**DANE COUNTY DEPT. OF
PUBLIC WORKS, HIGHWAY &
TRANSPORTATION**

ADDENDUM 1

RFB NO. 317033 - ADDENDUM NO. 1

DORN CREEK SEDIMENT REMOVAL

1
7 **WOODY DEBRIS RESTORATION DETAIL**
NO SCALE

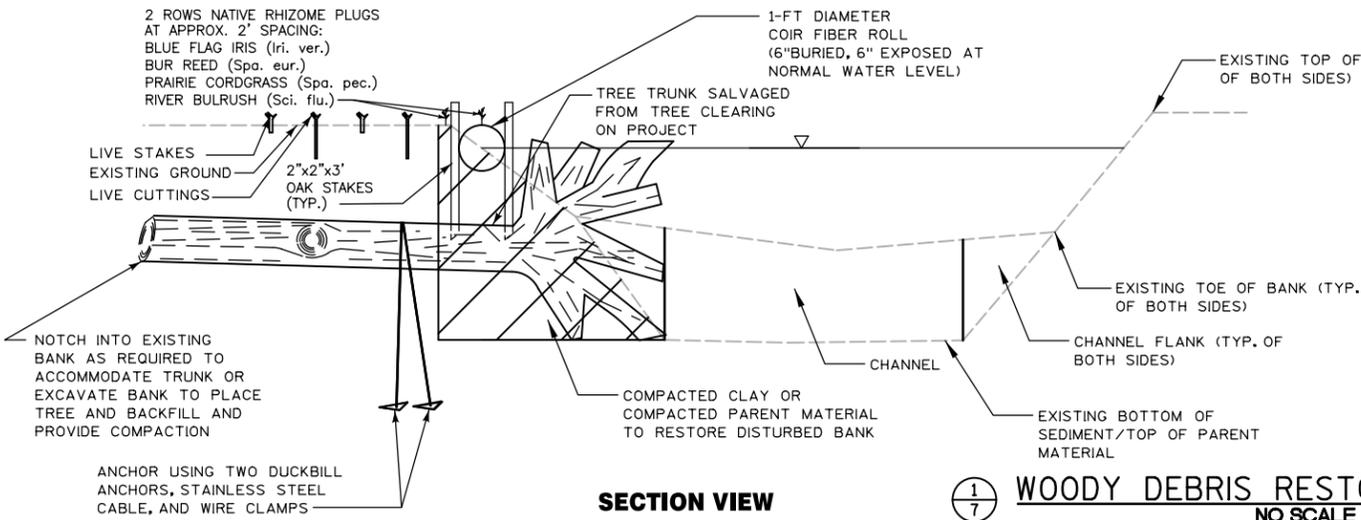
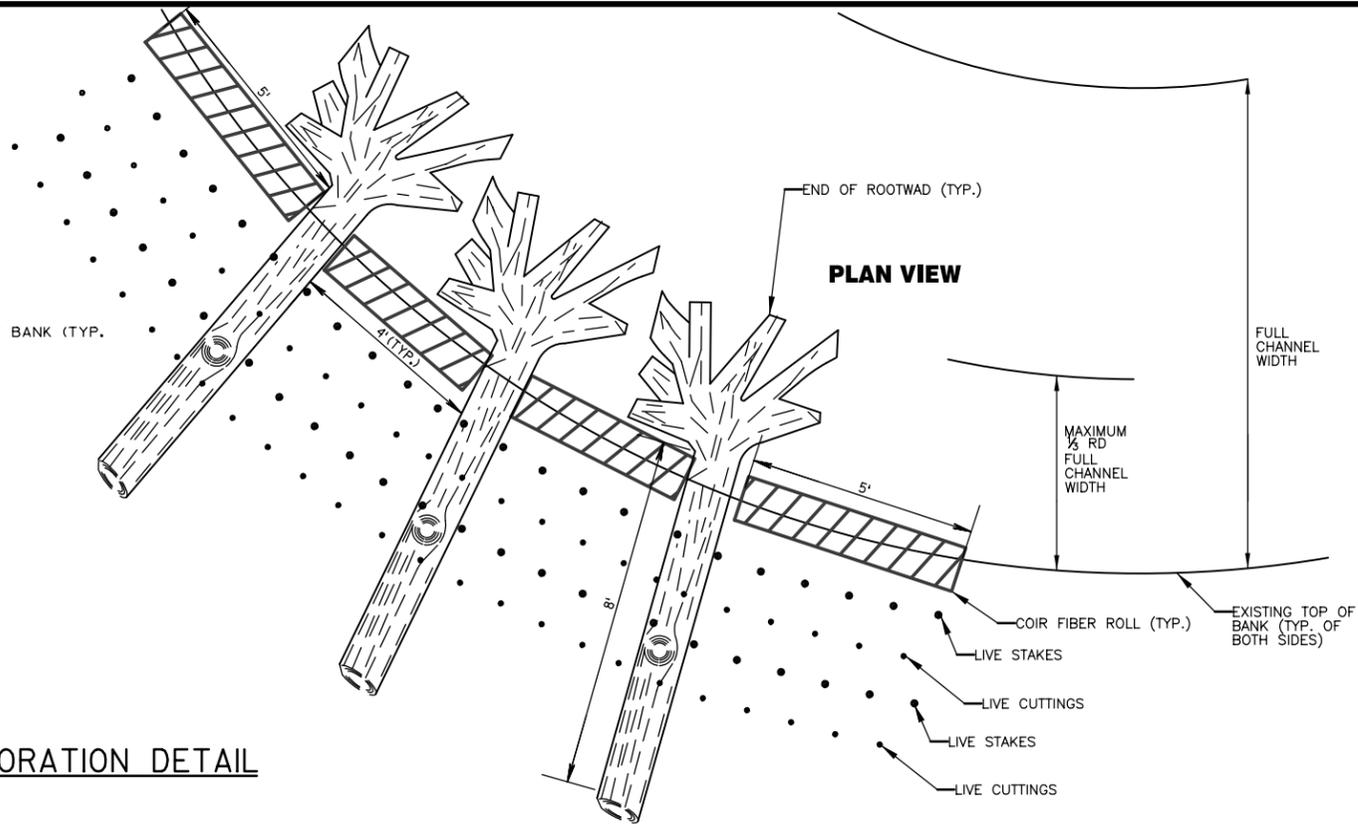
2. Section 02285 Woody Debris Restoration

Change: Delete Section 02285 2.01 B. and replace with the following: "Woody debris shall have an 8-inch to 12-inch diameter, and a minimum of 8 feet of the trunk must be attached to provide for adequate anchoring in the bank."

1. USE 8" TO 16" DIA. HARDWOOD TREE TRUNKS FOR WOODY DEBRIS.
2. TREE TRUNK WITH ROOTWAD INTACT WILL BE HARVESTED FROM AREAS CLEARED AT DREDGING SPOILS DEWATERING SITE.
3. PLANT LIVE STAKES, LIVE CUTTINGS, AND PLUGS PER SPECIFICATION SECTION 02999.
4. CLEAR OVERBANK AREA ONLY AS NECESSARY TO INSTALL WOODY DEBRIS RESTORATION DETAIL.
5. END OF ROOTWAD SHALL EXTEND INTO CREEK NO FURTHER THAN 1/2 RD THE FULL CHANNEL WIDTH AS MEASURED BETWEEN EXISTING TOP OF BANKS.

6. ANCHOR SYSTEM: CABLE SHALL BE 1/4" DIAMETER TX9 T302/T304 STAINLESS STEEL AIRCRAFT CABLE. DUCKBILL ANCHOR SHALL BE MODEL 88 AS MANUFACTURED BY FORESIGHT PRODUCTS, OR EQUAL. WIRE CLAMPS SHALL BE COMPATIBLE WITH CABLE AND ANCHOR. FOR EACH TRUNK, INSTALL TWO ANCHORS (ONE ON EACH SIDE OF THE TRUNK) TO SUFFICIENT DEPTH TO ACHIEVE ANCHORING AND CLAMP CABLE TO EACH ANCHOR.

HYDRAULIC DREDGING TYPICAL SECTION AND WORK ZONES
NO SCALE

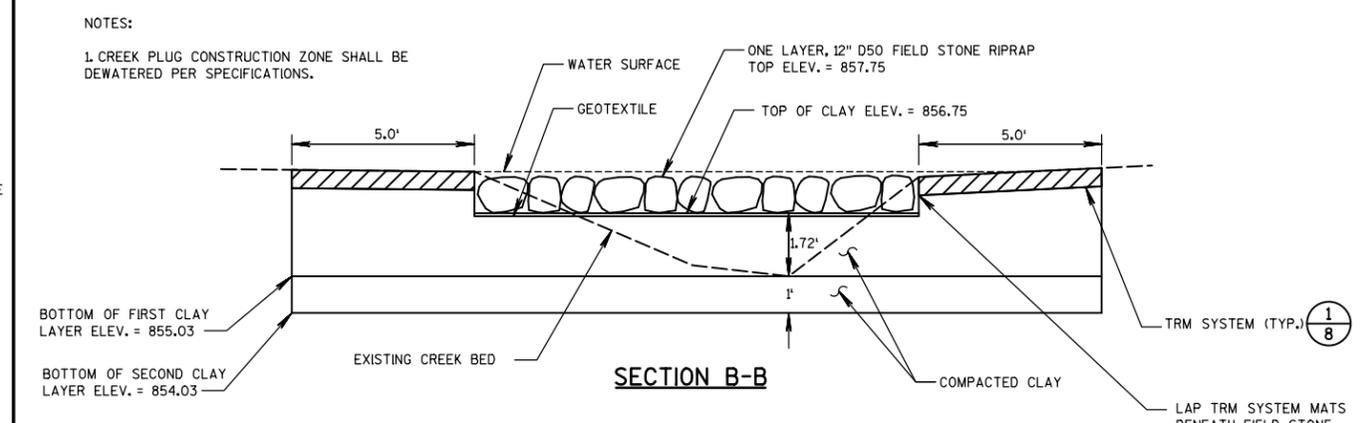
5. Sheet 8

Delete current Sheet 8; replace with new Sheet 8, issued with this Addendum.

DATE:	REVISIONS	NO.
9/21/17	DETAIL 2/8 MODIFICATIONS	1
